**Request for Additional Information No. 378(4409, 4513, 4490), Revision 2
Supplement 3**

U. S. EPR Standard Design Certification

Docket No. 52-020

**QUESTIONS for Containment and Ventilation Branch 1 (AP1000/EPR Projects)
(SPCV)**

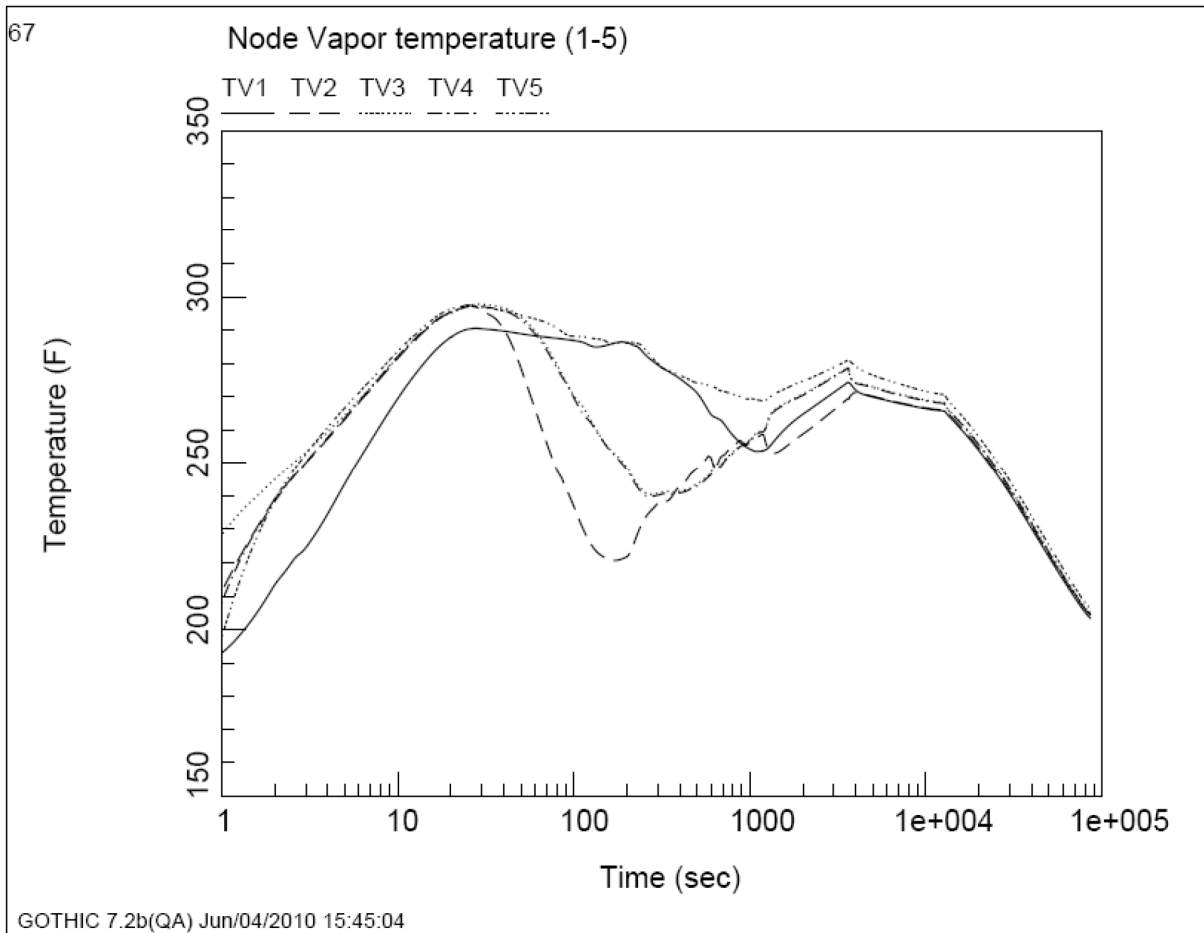
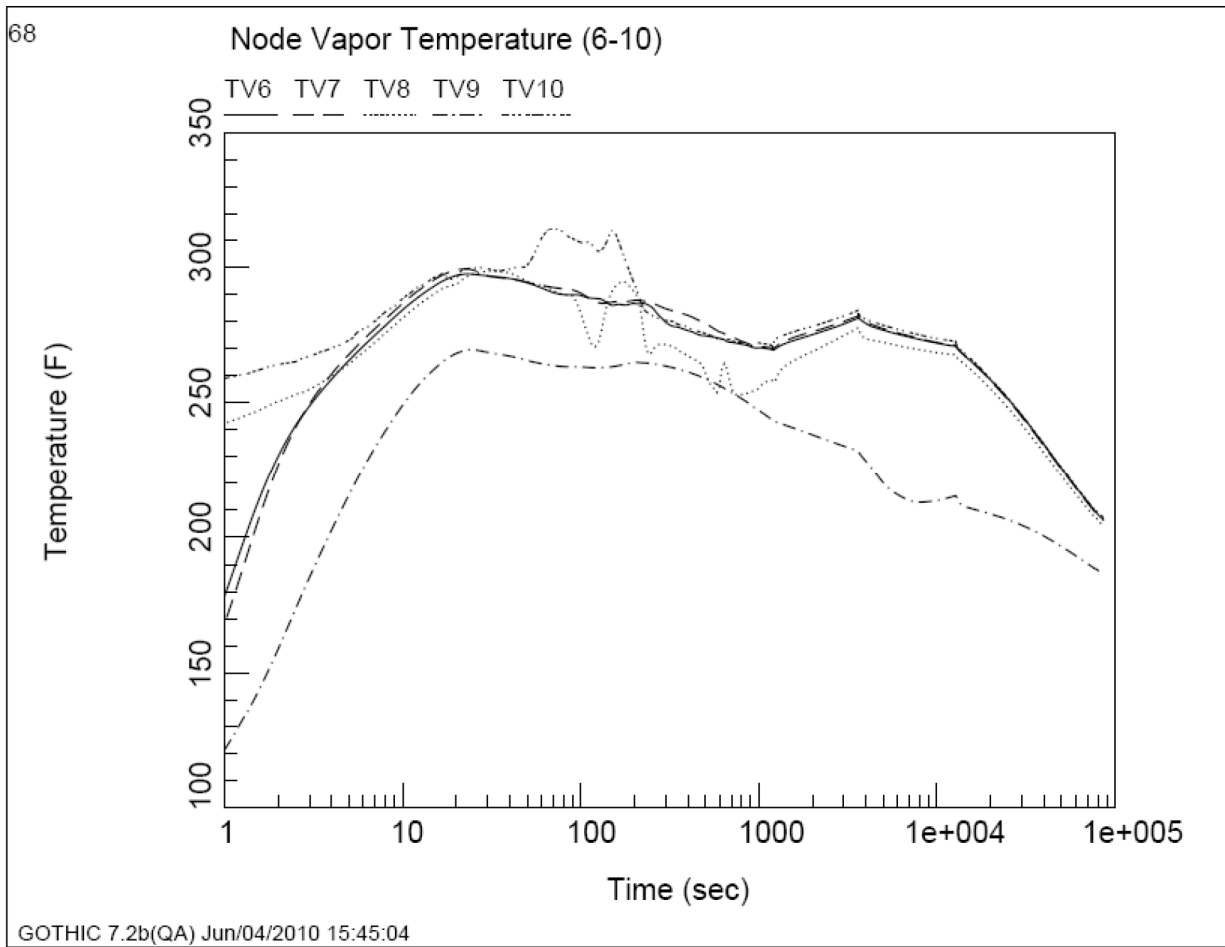
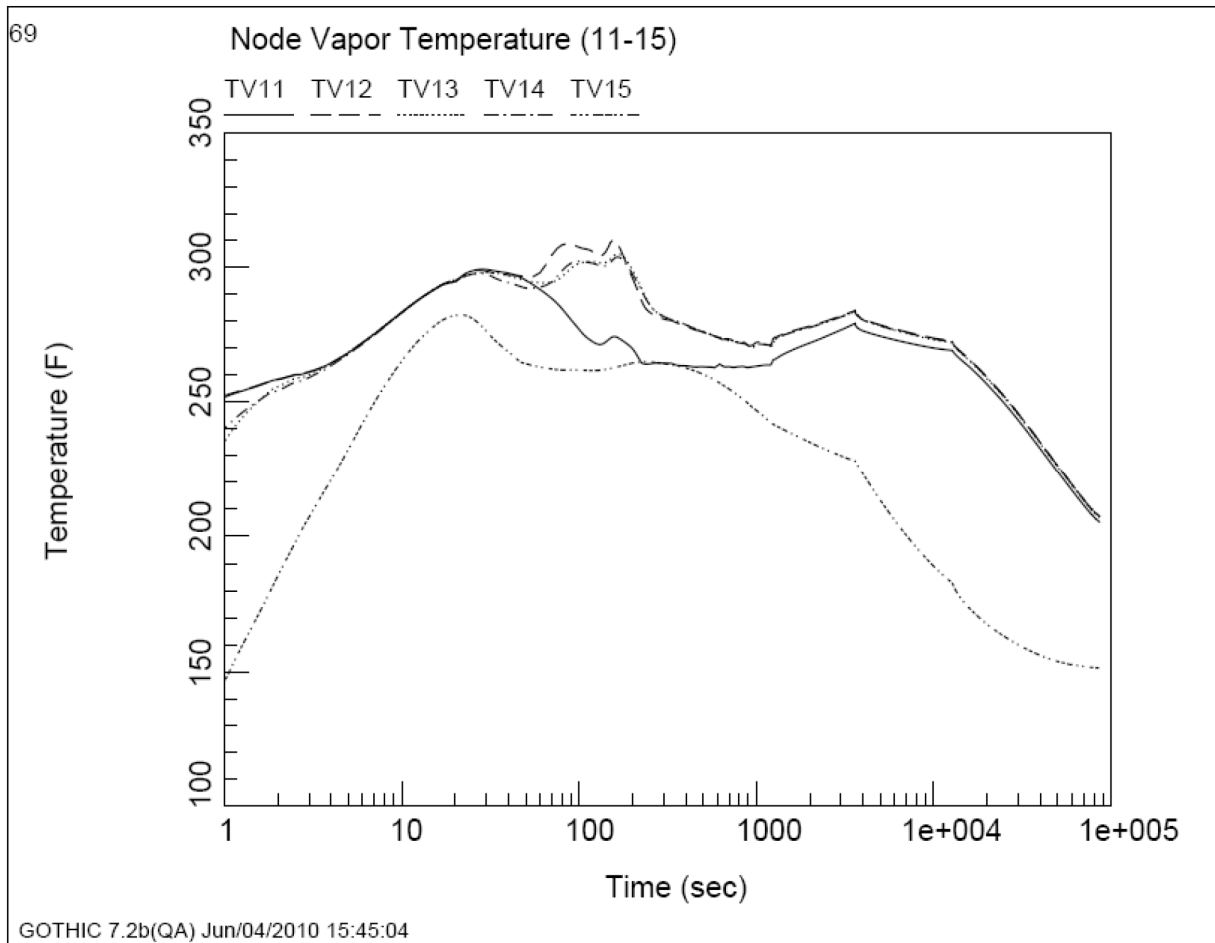
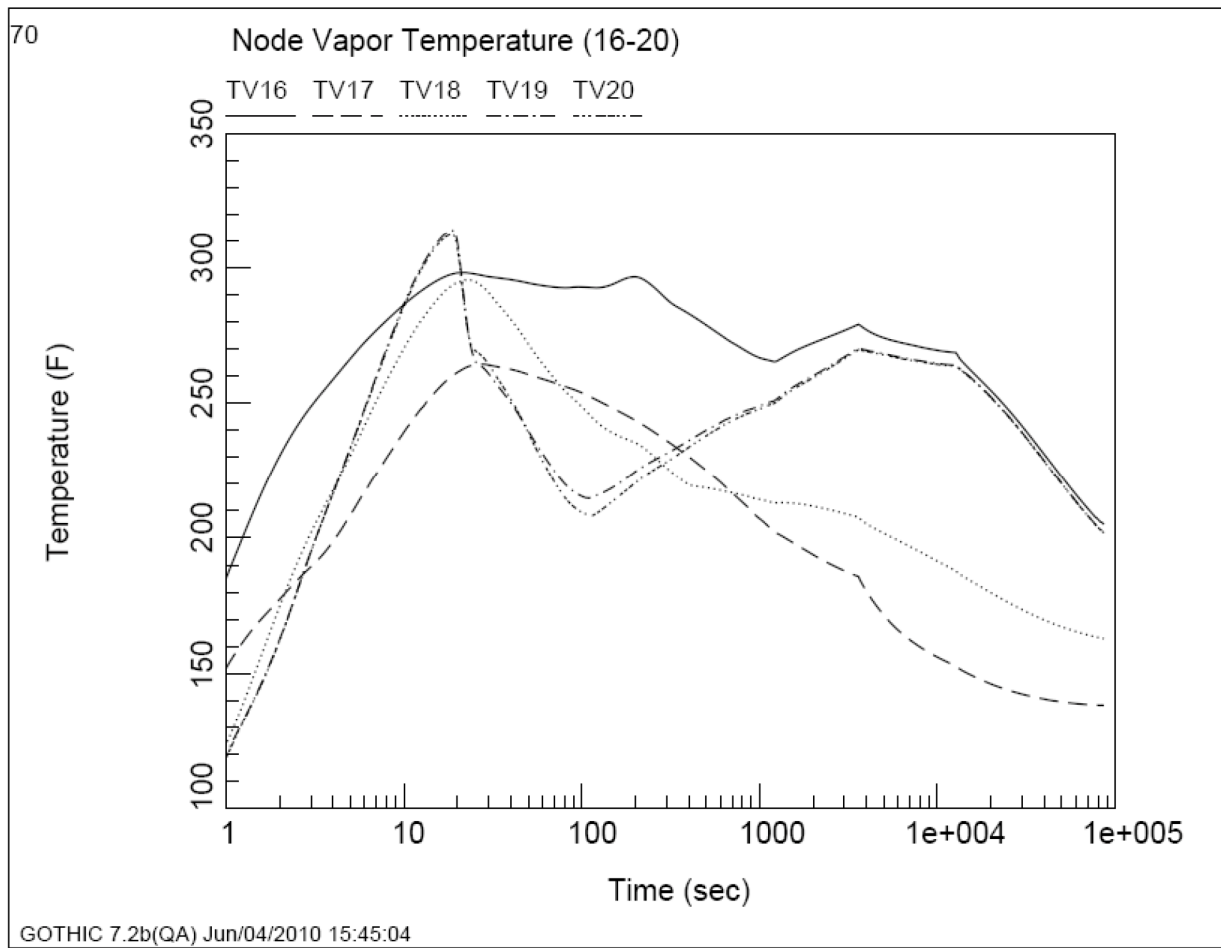
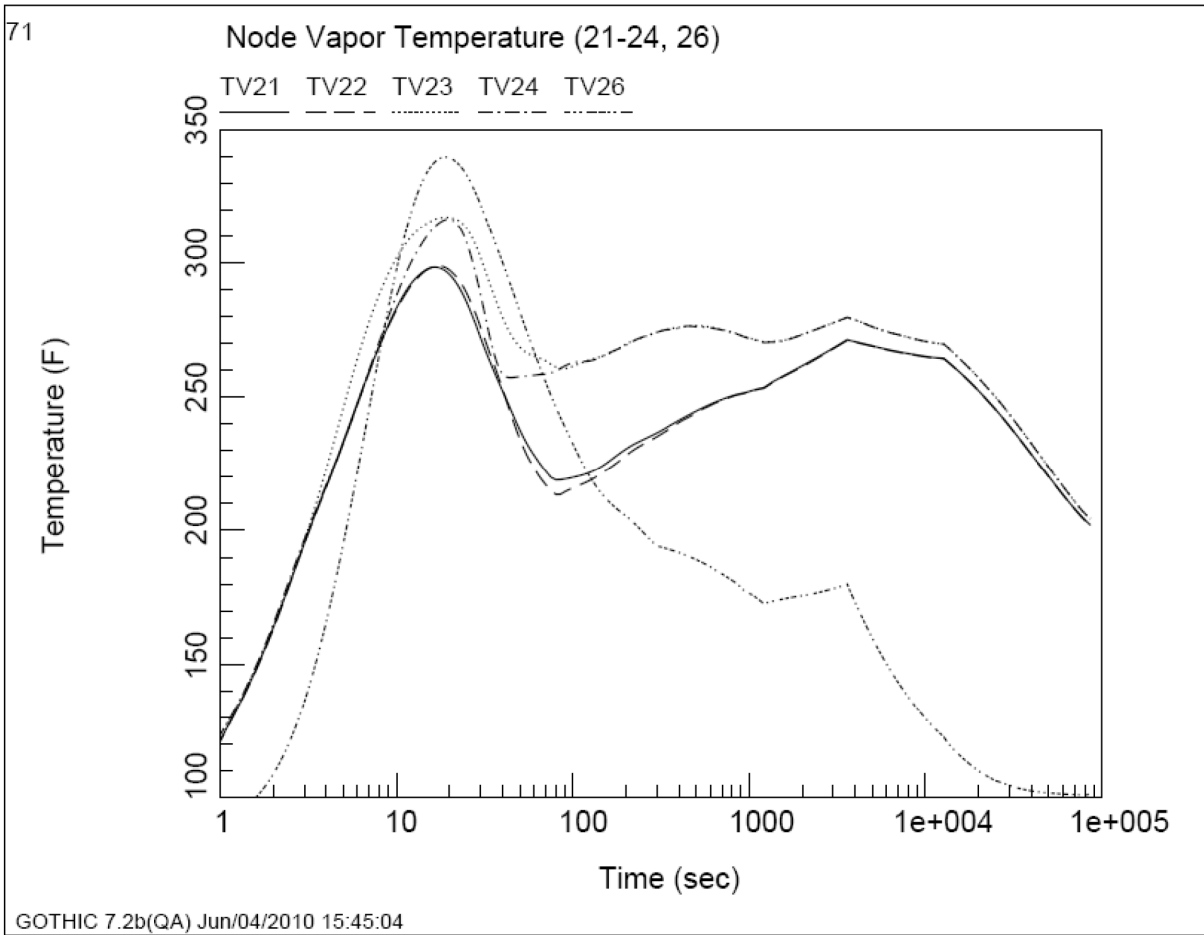
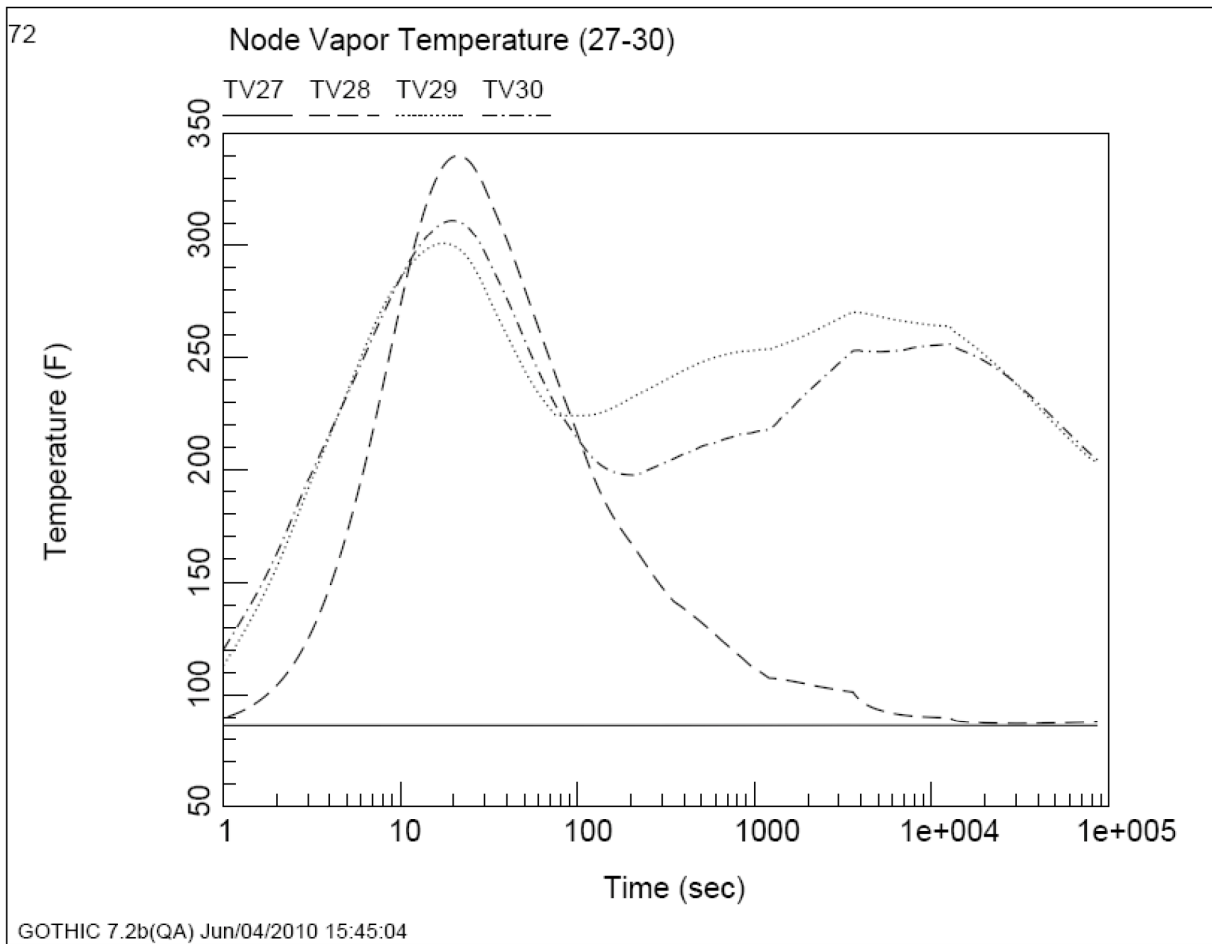
- a. Location of the maximum temperature reported in the FSAR (elevation and sub- divided node or lumped parameter node).
- b. Time history plots for atmospheric temperatures in the sub-divided dome (at elevations along the containment centerline, (19 elevations). Use the same time scale as the FSAR.
- c. Time history plots for atmospheric temperature below the dome (lump parameter nodes 1-30, excluding sub-divided dome region). Use the same time scale as the FSAR.
- d. Time history plots for gas velocity in pathways (FP #31 and 53 – rupture foils; FP# 11 and 12 – IRWST dampers; FP# 74 and 82 – middle annulus to dome; FP# 115 and 123 – upper annulus to dome). Use the same time scale as the FSAR.

- a) The temperature reported in U.S. EPR FSAR Tier 2, Figure 6.2.1-17 is the vapor temperature in the room that contains the break (equipment room – lumped parameter node #10).
- b) Figure 06.02.01-88-1 through Figure 06.02.01-88-4 show the time history atmospheric temperature for the sub-divided dome region. The temperatures are taken along the containment centerline. The plots are divided based on elevation, with Level 1 at the bottom of the dome and Level 19 at the top.
- c) Figure 06.02.01-88-5 through Figure 06.02.01-88-10 show the time history atmospheric temperature for volumes below the dome region (lumped parameter nodes one through 30, excluding the sub-divided node region).
- d) Figure 06.02.01-88-11 through Figure 06.02.01-88-14 show the time history gas velocity for the requested pathways.
